SUBJECT: Negative Declaration for Kailua Landfill Closure
TMK: 7-4-08:16

FINAL ENVIRONMENTAL ASSESSMENT
IN ANTICIPATION OF A NEGATIVE DECLARATION
CHAPTER 343, HAWAII REVISED STATUTES (HRS)

KAILUA LANDFILL CLOSURE

Figure 4.
Rock and Soil Map in
Vicinity of Kailua Landfill

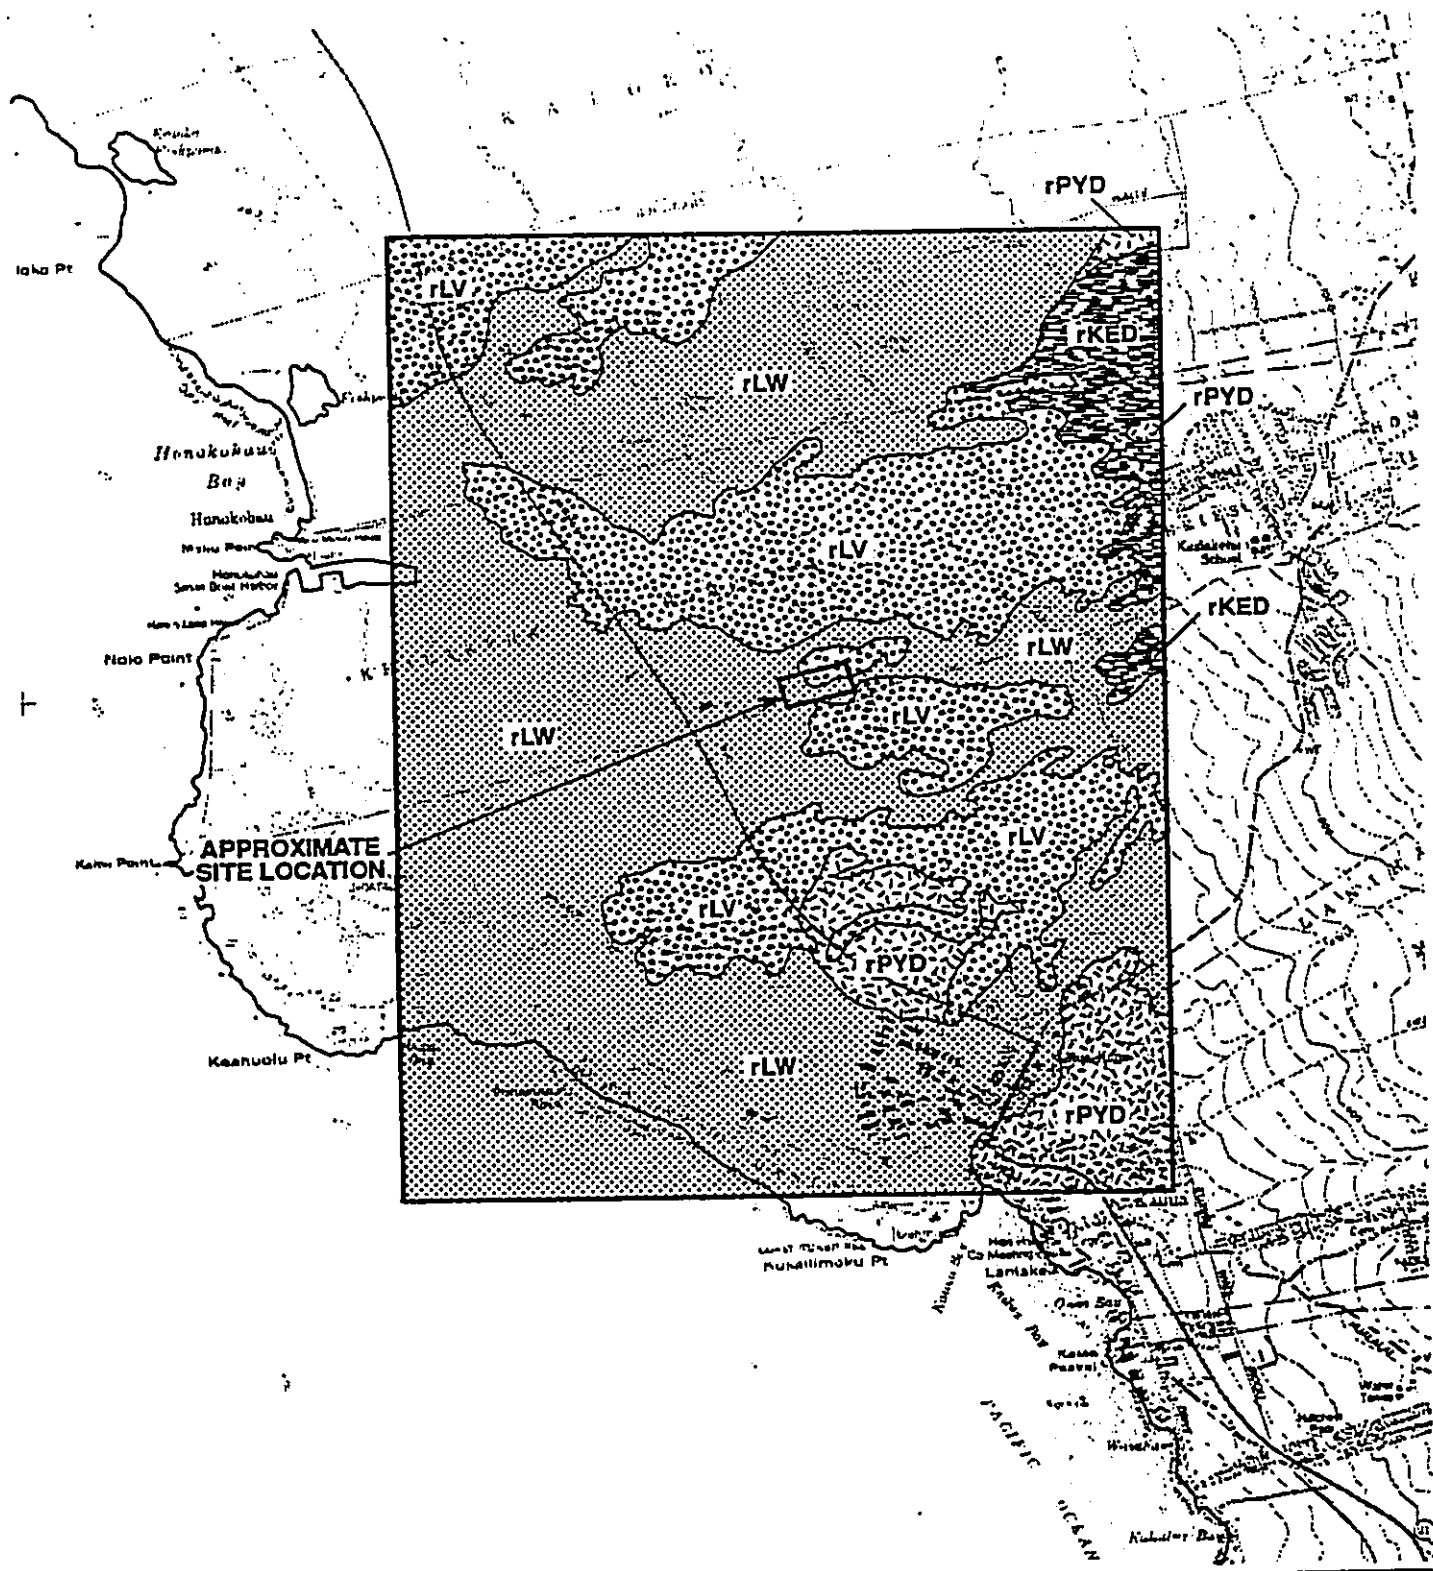
4. Page 4, Item 2. The EA should identify the names of the adjacent landowner/lessees.
5. Page 9, Soils. In reviewing Figure 4, the Kaimu Series (rKED) is situated further mauka of the subject property.
6. The EA should include discussions on historic sites and land use.
7. Page 11. The EA should include discussions on what kinds of mitigative measures will be taken with regard to potential groundwater contamination of the breachish lens.
8. Page 13. Items 7, 8 and 9 should not be included as criteria for an EIS determination. Item 7 could be included in the Purpose section. Items 8 and 9 would be appropriate under the Land Use section.
9. Throughout the EA, the word "Kealakehe" should be corrected to read "Kealahaha".
